**New Reactors Division – Generic Design Assessment**  
**Step 4 Assessment of External Hazards for the UK HPR1000 Reactor**

Assessment Report ONR-NR-AR-21-006  
Revision 0  
January 2022

**Figure 8:** An example section illustrated to show the angles for wind-borne missiles that might penetrate rooms adjacent to the building boundary. (Ref. 72)

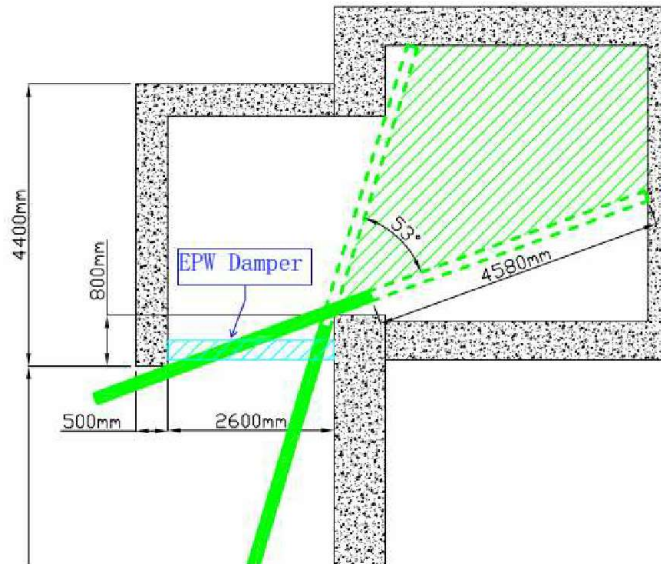
249. The RP has provided additional evidence to support the conclusions of the analysis in Revision C of the 'Tornado Safety Evaluation Report' (Ref. 72). This includes sections illustrating the angles considered for missiles striking different openings on nuclear island structures (Figure 8). I judge the RP has provided sufficient evidence to support the conclusions of the analysis.

252. I have considered the nuclear safety consequences of the shortfalls associated with inverse-L structures, and I judge it is reasonable for this modification to be implemented during site-specific stages for the following reasons:

- The preferred option for the vulnerable inverse-L structures is a steel grille installed at the base of the inverse-L structures to prevent missile penetration. This modification has been deferred to site-specific stages as it is dependent on the detailed design of the inverse-L structures.

**Figure 10:** Sinusoidal temperature profile used for calculating the solar gain input to HVAC analysis. (Ref. 202)

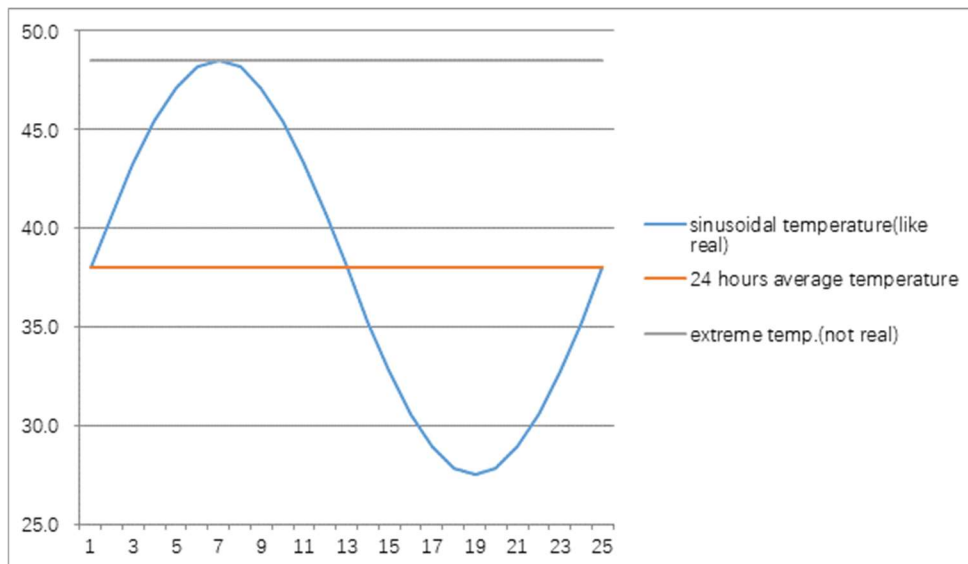
278. The RP has defined a 24 hours temperature varying, sinusoidal profile (Figure 10):
- Duration: 24 hours
  - Average temperature: 38 °C
  - Maximum temperature: 48.5 °C

- Minimum temperature: 27.5 °C
279. I judge the RP's approach adequate for determining fabric heat gain in GDA given the absence of site-specific data. I expect a licensee to revisit the sinusoidal profile in light of site-specific information as normal business during site-specific stages.

280. The RP's HVAC analysis shows that for a diurnally varying temperature profile, the extant chiller sizes of Type B systems are sufficient to manage external hazards loadings. The RP estimated that, based on the FCG3 reference design, the cooling loads will increase by 3%, but has demonstrated the chiller capacities can accommodate this increased loading for DCL [MCRACS], DVL [EDSBVS] and DEL [SCWS] systems. The ONR Mechanical Engineering Inspector has raised AF-UKHPR1000-0128 for a licensee to demonstrate the chillers can satisfy the 48.5 °C extreme ambient temperature during detailed design.

**Figure 11:** Flow of requirements between UK HPR1000 schedules. (Ref. 340)

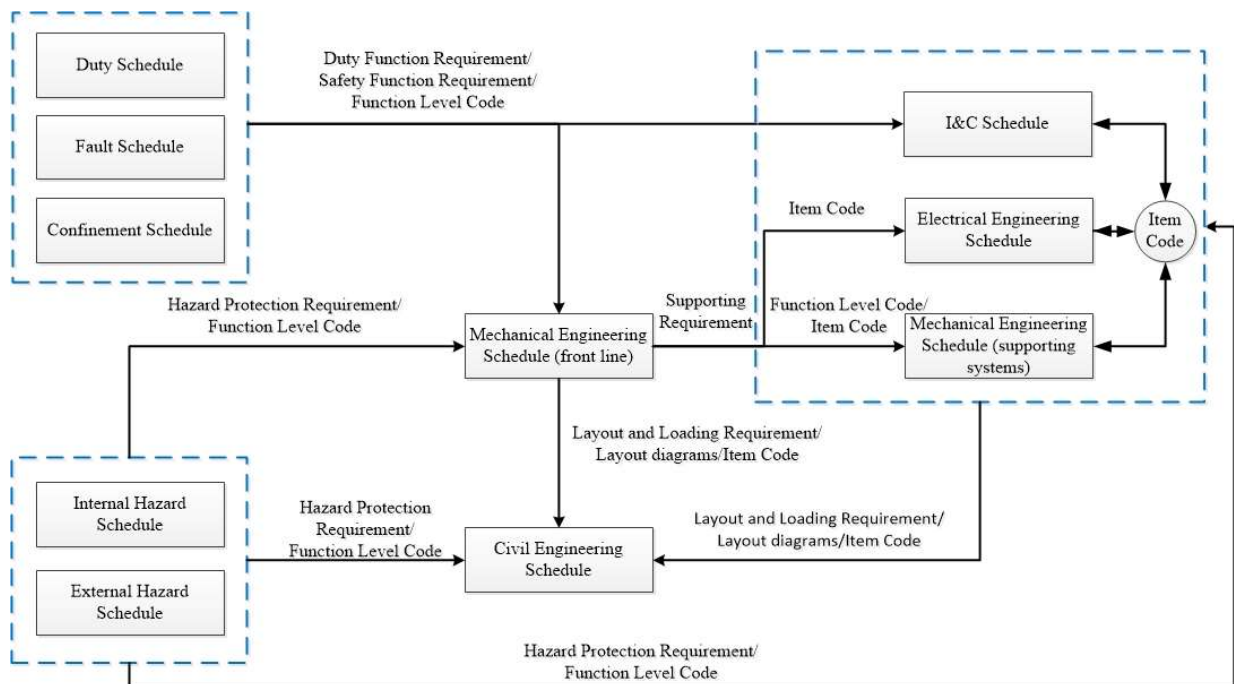
547. Figure 11 does not show a link between the external hazards and fault schedules (Ref. 301). External hazards can initiate a number of design basis conditions (faults), such as LOOP and LUHS (sub-section 4.13). The “Potential Consequences caused by External Hazards” column in the ‘External Hazards Schedule Report’ (Ref. 79) identifies the design basis conditions that can be initiated by the various hazards. A footnote in Appendix A of the ‘External Hazards Schedule Report’ (Ref. 79) states that: “For conservative reason, if a design basis fault corresponds to several events with different conditions in Fault Schedule, the design basis fault caused by external hazards is linked to the most severe one. For instance, the LOOP caused by tornado is linked to the “Long Term LOOP of 168 Hours Duration” by default.” I judge the RP’s approach conservative for the purposes of GDA. A licensee may wish to enhance the links between the external hazards and fault schedules as part of normal business.

**Figure 12:** Logic flow diagram for BFX external hazards evaluation. (Ref. 353)

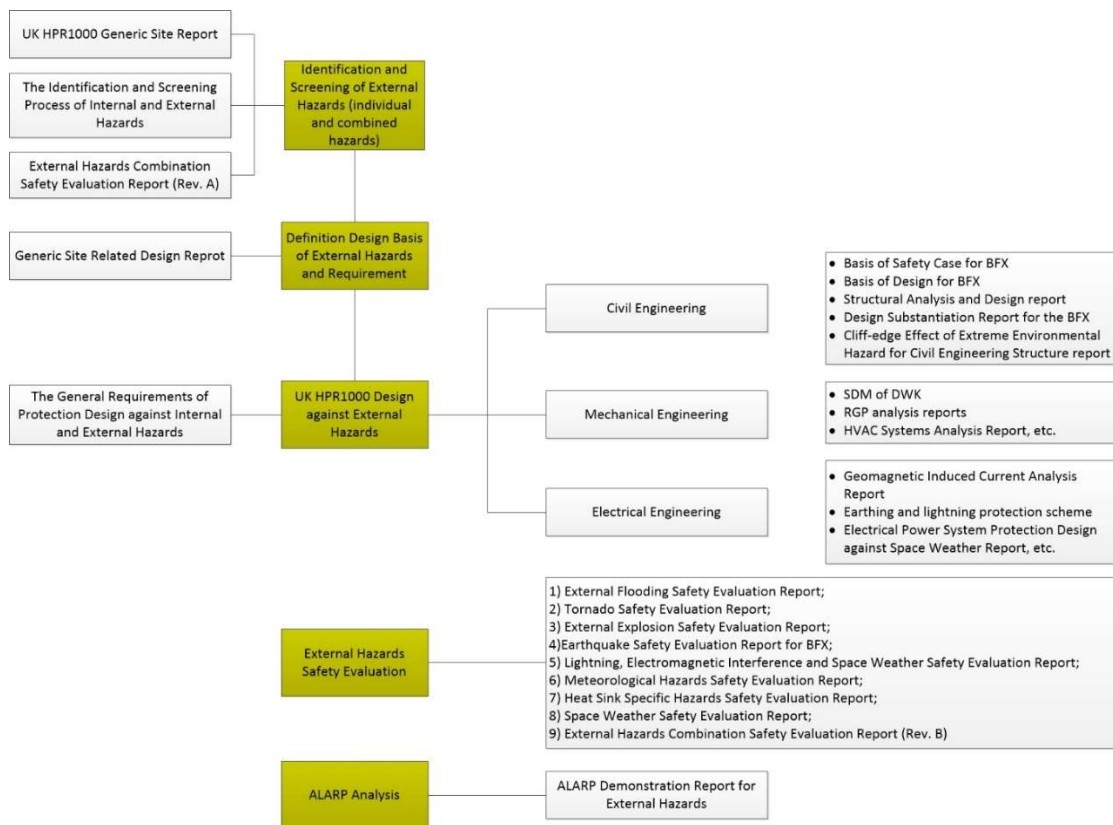
576. My assessment of documentation shown in Figure 12 has identified the following:

- The malicious aircraft impact safety case has identified a number of potential design shortfalls that need to be protected. The RP has committed to undertaking this work during site-specific stages once the site-specific layout is known, and I have raised Assessment Finding AF-UKHPR1000-0093 to ensure the adequacy of this work.

- Links are present between the external hazards schedule and civil engineering safety case documentation and requirements are traceable.
- The RP has provided qualitative arguments that the modified design of BFX remains robust against external hazards.

577. Overall, based on the documentation I have sampled, I am satisfied that the safety justification for BFX against external hazards is consistent with the wider external hazards safety case for GDA.
